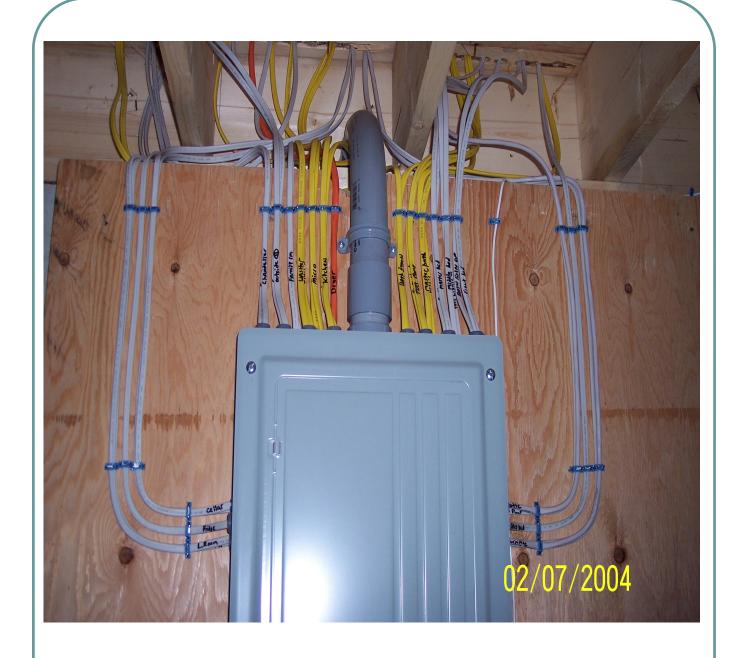
When CSST is used Manufacturer's nail plate is required

Proper nail plates required at penetration of framing members for top and bottom plates

Take care of this *before* you call for inspection

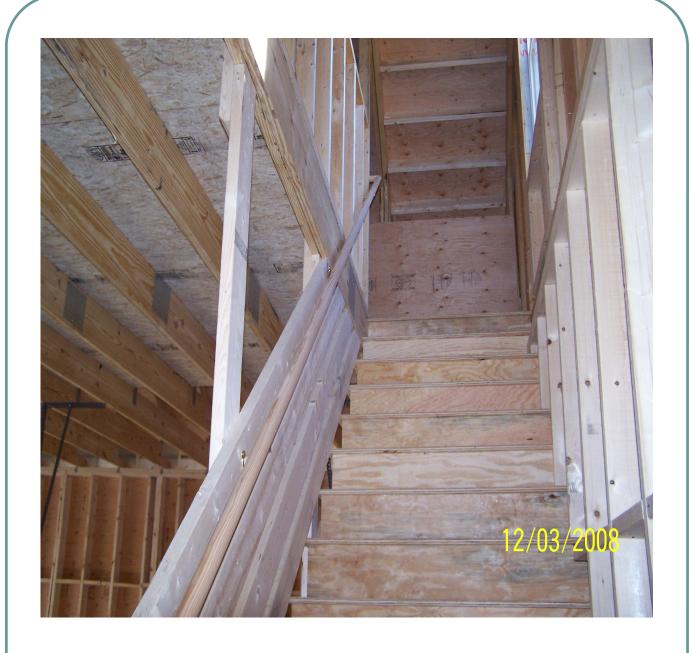
Whoops?

Plates need to be supported with framing member—plates need to be continuous!

Not "preferred" method for routing and securing CSST

Protective sleeves are stripped back too far! Unnecessary kinks!
